CHANGE ORDER REQUEST

PROJECT NUMBER:	<u>1736</u>	SUBCONTRACTOR'S NAME:	<u>MULTIPLE</u>
PROJECT NAME:	<u>WORLD HERITAGE CENTER</u>	COST CODE NUMBER:	<u>MULTIPLE</u>
CHANGE ORDER #:	<u>ALTERNATE'S REPRICE</u>	SUB'S VENDOR NUMBER:	<u></u>
TRADE DESCRIPTION:	<u>MULTIPLE</u>	DATE:	<u>9/6/2023</u>

SCOPE OF WORK: REPRICING THE ALTERNATES THAT WERE NOT PICKED UP ON CONTRACT

SITE PLAN

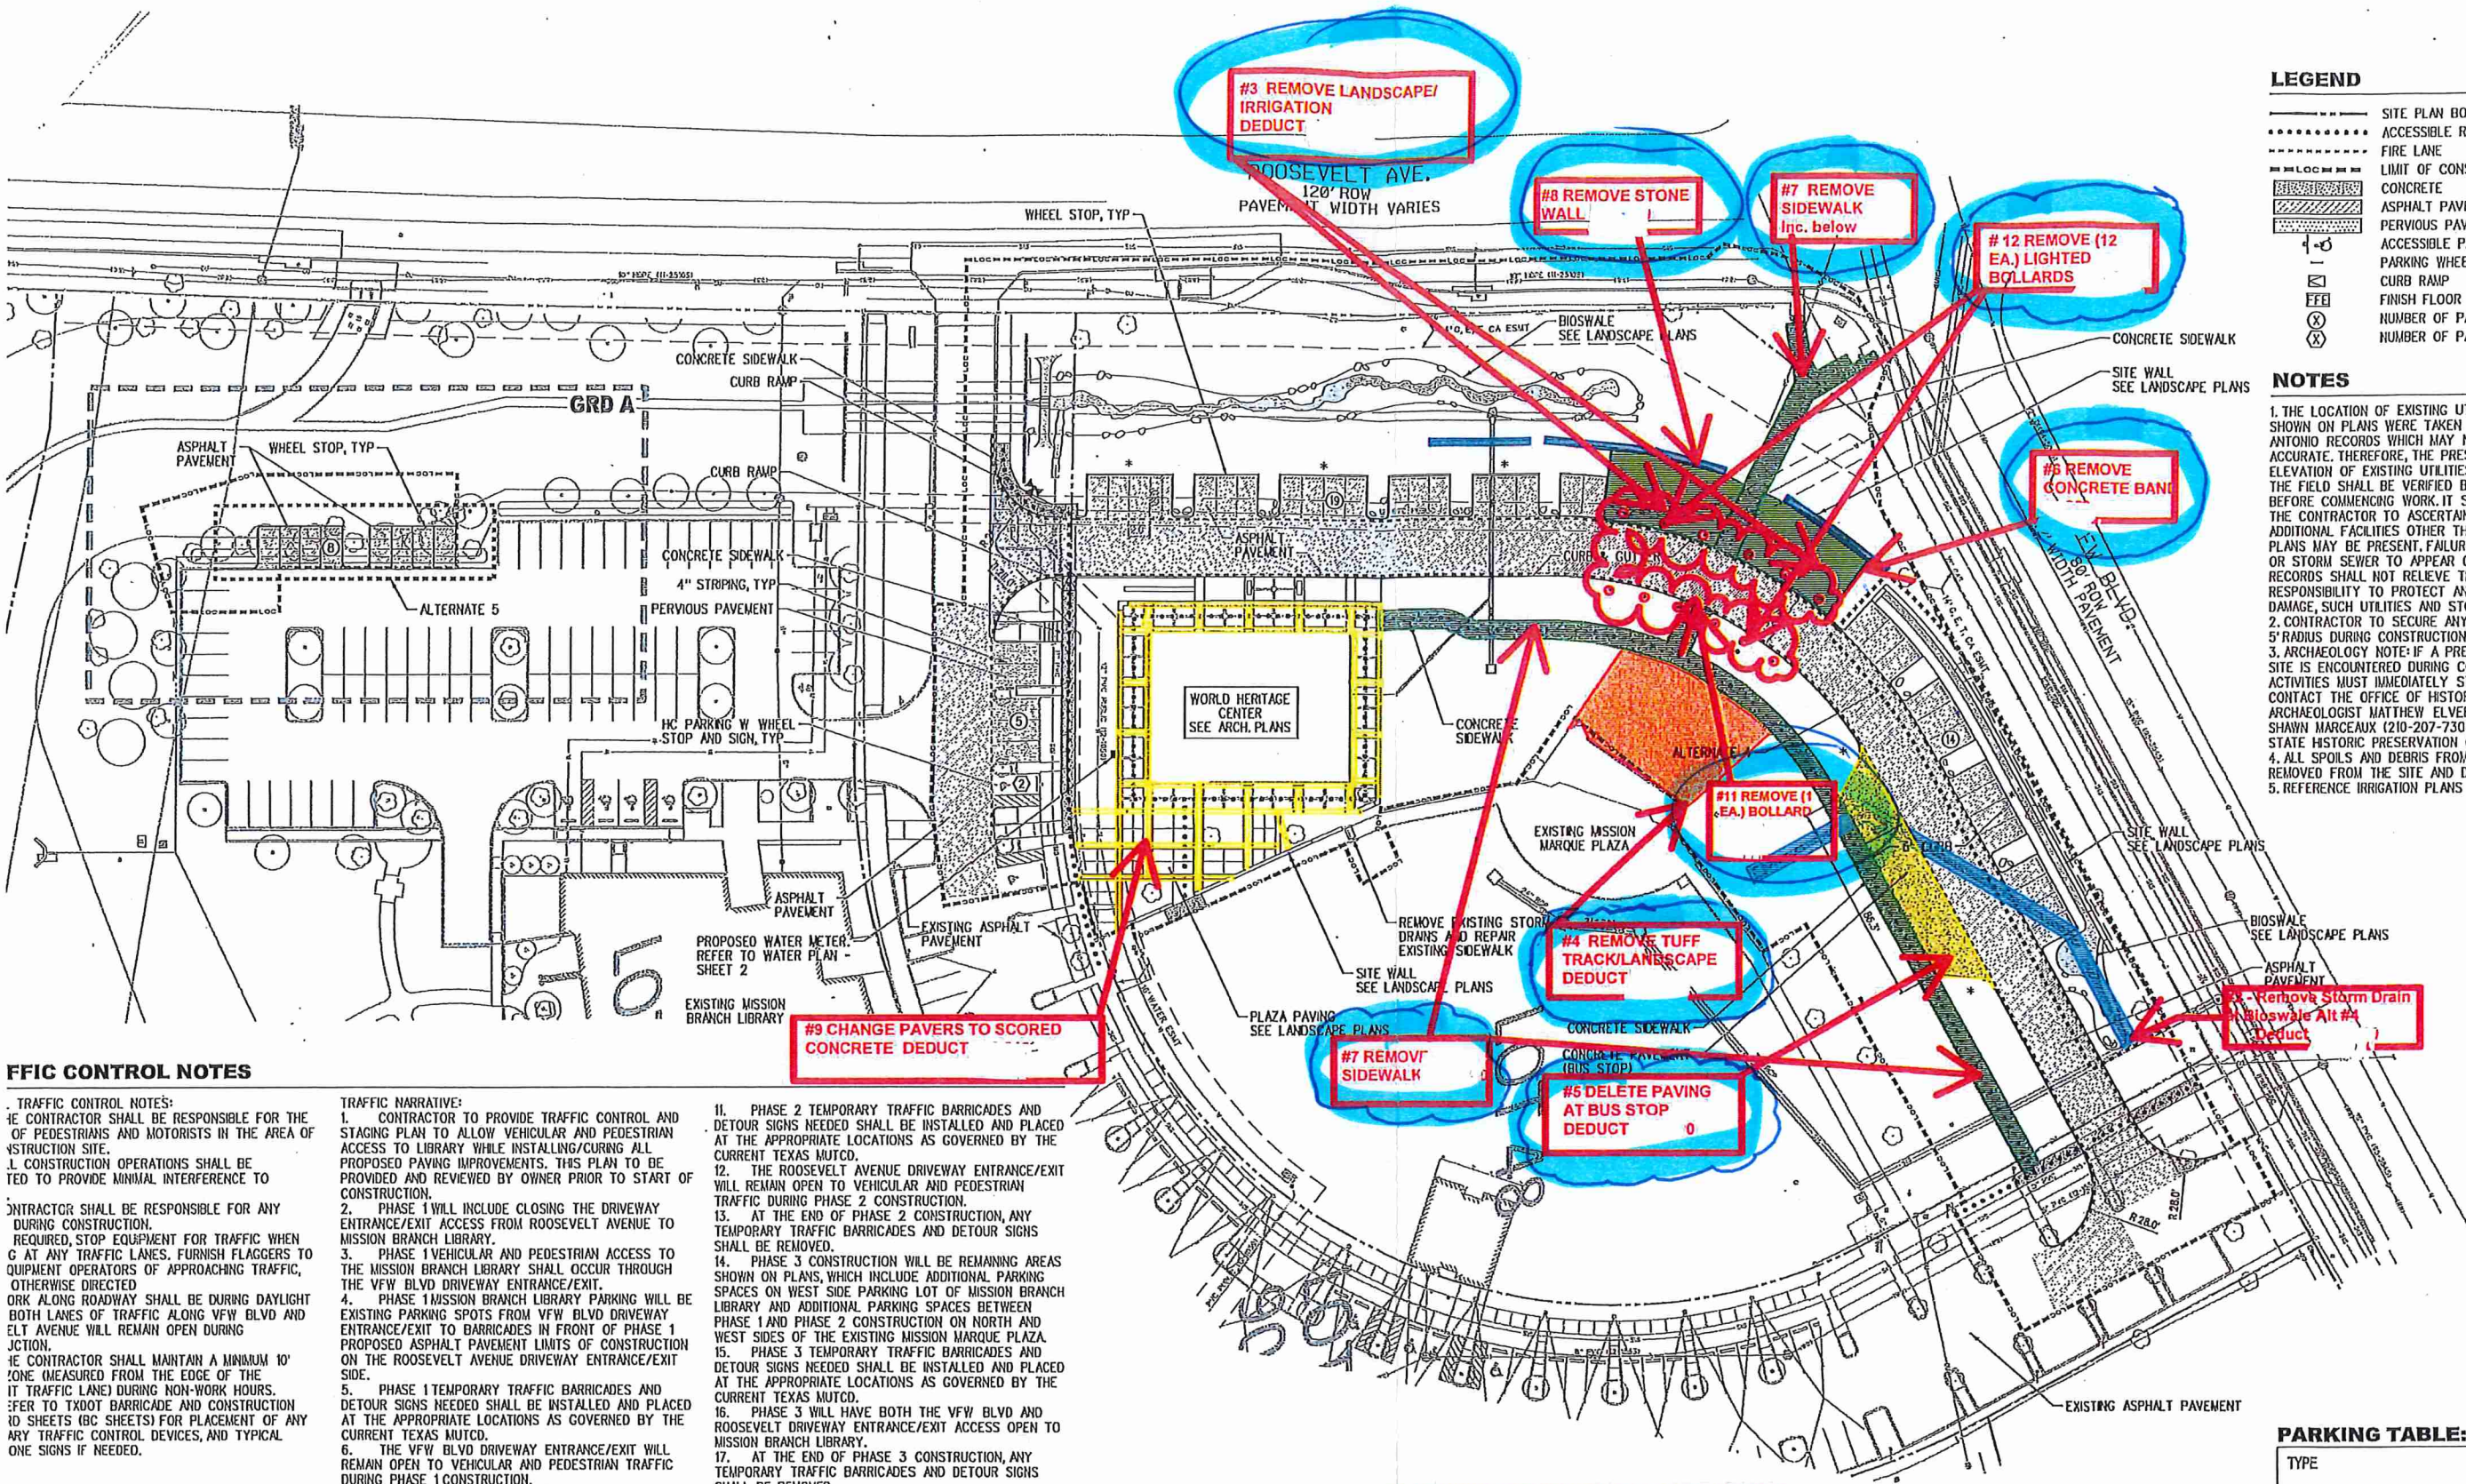
EXCLUSIONS: PRICE INCREASES, MATERIAL DELAYS, PER ATTACHED PLAN, & PROJECT SCHEDULE DELAYS

#1 - VE LIME STABILIZATION TO GEO-GRID DEDUCT
#13 - ISSUE CONTRACT EARLY
#14 - CHANGE IN UTILIZATION PLAN

BOUND - PHASE II
COVERED PAVILION - 7' x 5' - ?
LEAN TO AWNING TYPE STRUCTURE.
PROVIDE TIME FRAME.
